19. SEVERE ACCIDENTS

As part of the AP1000 advanced design certification application, the applicant submitted a PRA in accordance with the requirements of 10 CFR 52.47 and the Commission's policy statement entitled, "Severe Reactor Accidents Regarding Future Designs and Existing Plants." The staff's assessment of the AP1000 PRA consisted of the traditional evaluation of events that could lead to core damage and offsite consequences, as well as an evaluation of what the PRA revealed about the AP1000 design.

Figure 19.1-1 Breakdown of Containment Release Frequency Based on the Level 2 PRA Results Reported by Westinghouse (Baseline PRA, Internal Events)

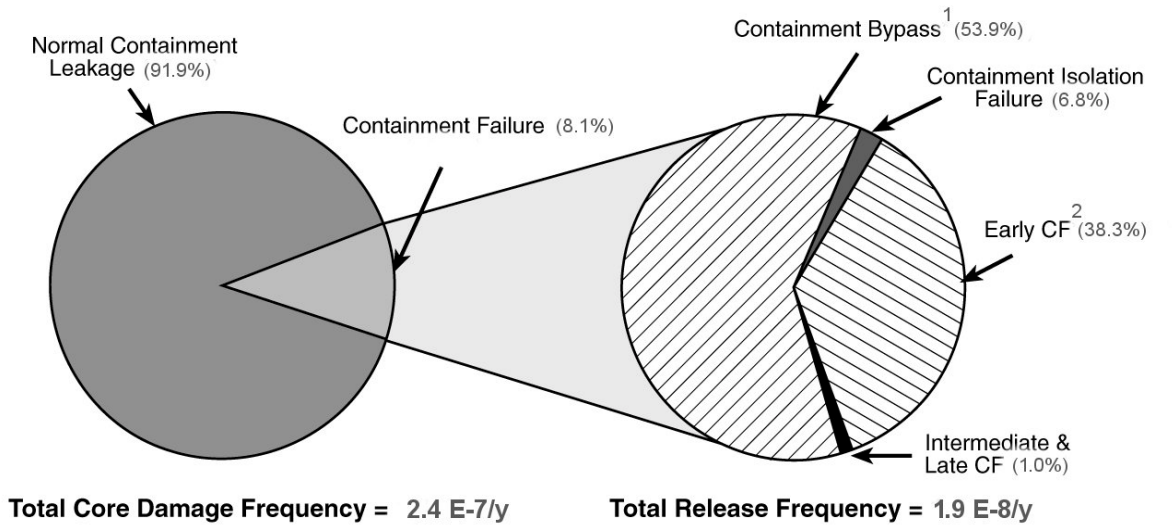
Figure 19.1-1 and Table 19.1-4 of this report present the frequencies of the various containment release categories and the fractional contributions by release category to the total LRF. Section 19.1.3.2.2 of this report further discusses the leading contributors to the various RCs.

Figure 19.1-2 Breakdown of AP1000 Containment Release Modes by Contributor, as Reported by Westinghouse

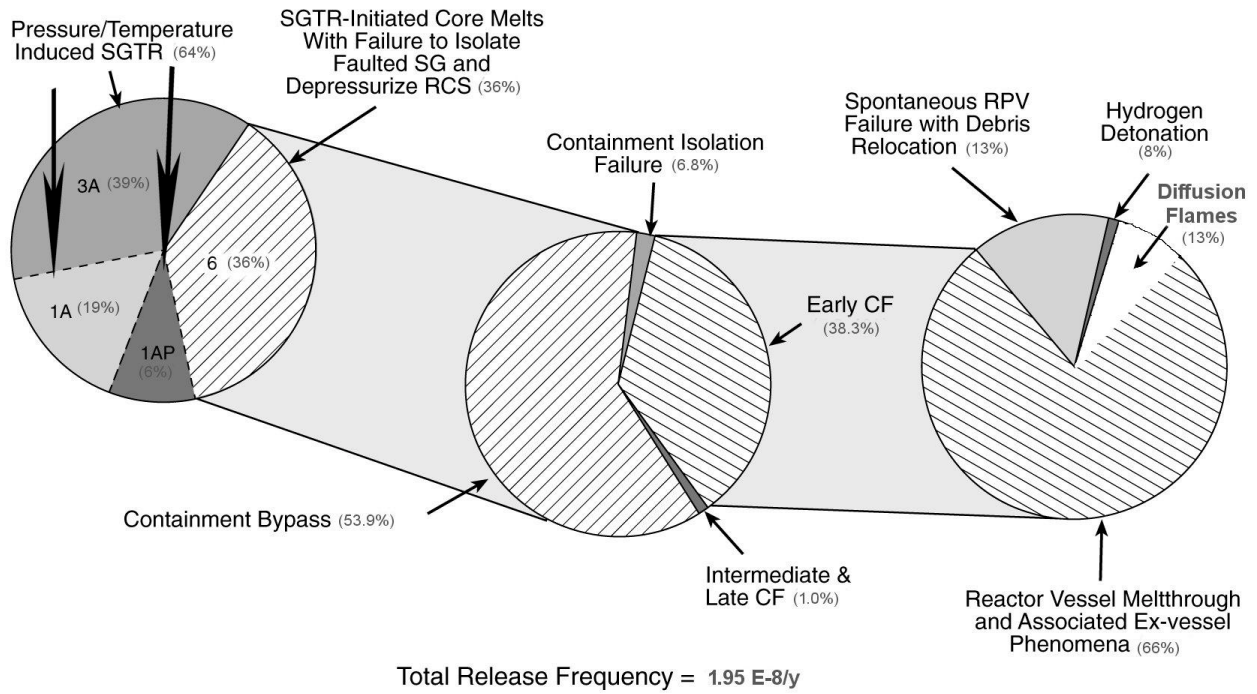
Figure 19.1-2 of this report identifies the important contributors to each of these RCs, which are discussed further in the sections that follow.

As shown in Figure 19.1-2 of this report, pressure- and temperature-induced SGTR sequences account for 64 percent of the containment bypass frequency. High-pressure core melt sequences are conservatively assumed to result in failure of the SG tubes because of either of the two following conditions:

Therefore, they are not reflected in the 36 percent contribution from SGTR events in Figure 19.1-2 of this report. Instead, these events are further evaluated in the CET, where they generally result in an intact containment and a benign source term. The assumption that the SG level will be maintained above the break in such sequences is important to the LRF and dose results, and will be further assured by inclusion of appropriate guidance on SGTR response within the severe accident management guidance to be developed by the COL applicant. This is part of COL Action Item 19.2.5-1.

Figure 19.1-3 Overall Dose Risk
Site Boundary Whole Body EDE, 24-Hour Dose

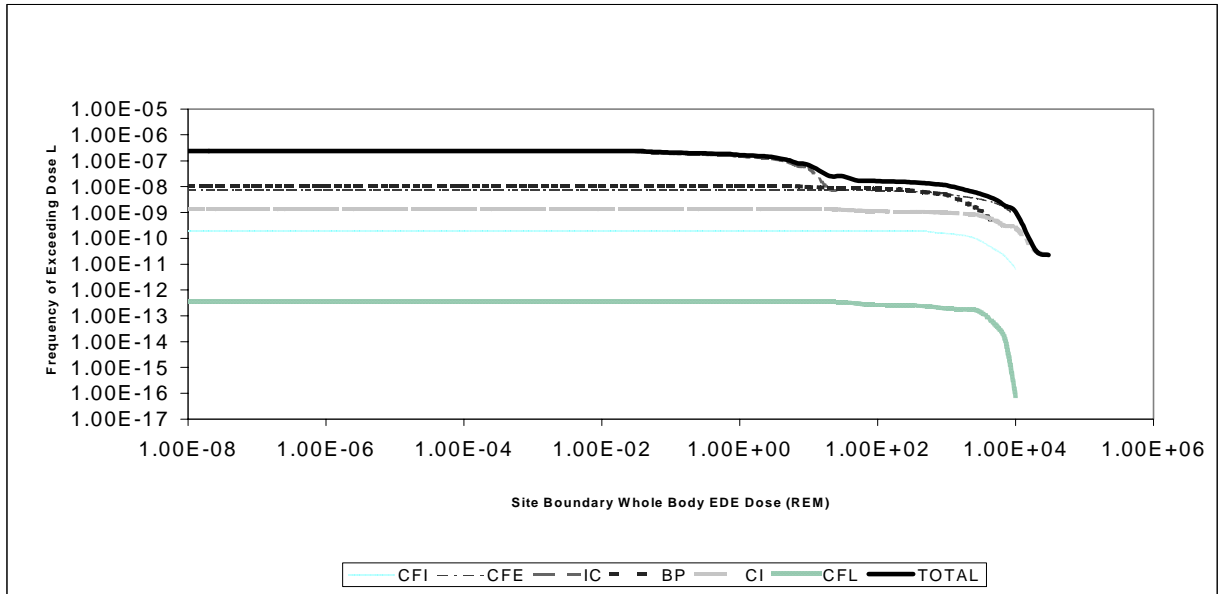
Table 19.1-5 and Figure 19.1-3 of this report present the contribution to risk from each of the release categories. The following observations can be noted:

- Based on Figure 19.1-3, the probability of exceeding 0.25 Sv (25 rem) at the site boundary (0.8 km (0.5 mile)) is essentially flat and close to unity for all release
